## **SPRING BROOK VILLAS SUBDIVISION,** **PHASE THREE**

APPLICATION NUMBER 15 DATE May 1, 2008

REQUEST Subdivision

# DETAIL SITE PLAN

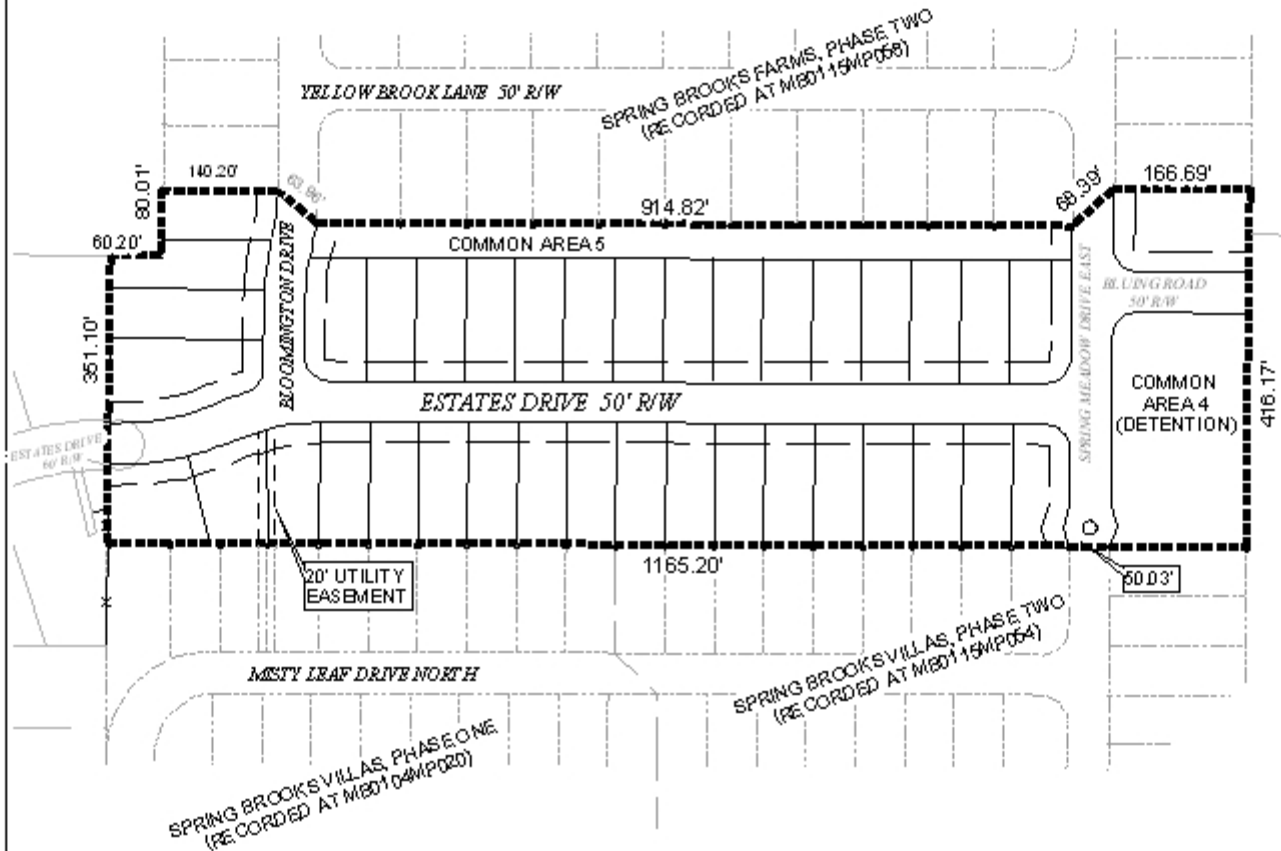
Development of the site will require the construction of new streets, which will connect to existing minor streets to the North, South and West of the site. A street-stub is being provided to undeveloped property to the East, as required by previous approvals. A traffic-calming device is also proposed next to Lot 111, as required by previous approvals. All roads must be built to County standards and accepted by the County, prior to the recording of the final plat.

As lots proposed for Phase Three of Spring Brook Villas will generally only have 60-feet of frontage, access management is a concern. Each lot should be limited to one curb-cut, with the size, design and location to be approved by Mobile County Engineering.

Common areas are proposed for the site. Notes are on the preliminary plat stating that maintenance shall be the responsibility of the property owners: the notes regarding the common areas, including the detention area, should also appear on the final plat.

The 25-foot minimum building setback is shown on the plat, but is not labeled. In addition to the note on the plat, the setback line should be labeled.

- 1) Construction of all streets to Mobile County standards, including the street-stub to the East, and acceptance of the streets by Mobile County prior to the recording of the final plat;
- 2) Provision of a traffic calming device on Spring Meadow Drive East, as depicted, subject to Mobile County Engineering approval;
- 3) Placement of a note on the final plat stating that each lot is limited to one curb-cut, with the size, design and location to be approved by Mobile County Engineering;
- 4) Labeling of the 25-foot minimum building setback line, and retaining of the note on the plat; and
- 5) Retaining of notes on the plat relating to common area maintenance, endangered/threatened species, buffering of commercial development, storm water compliance, wetlands, and lot size information.
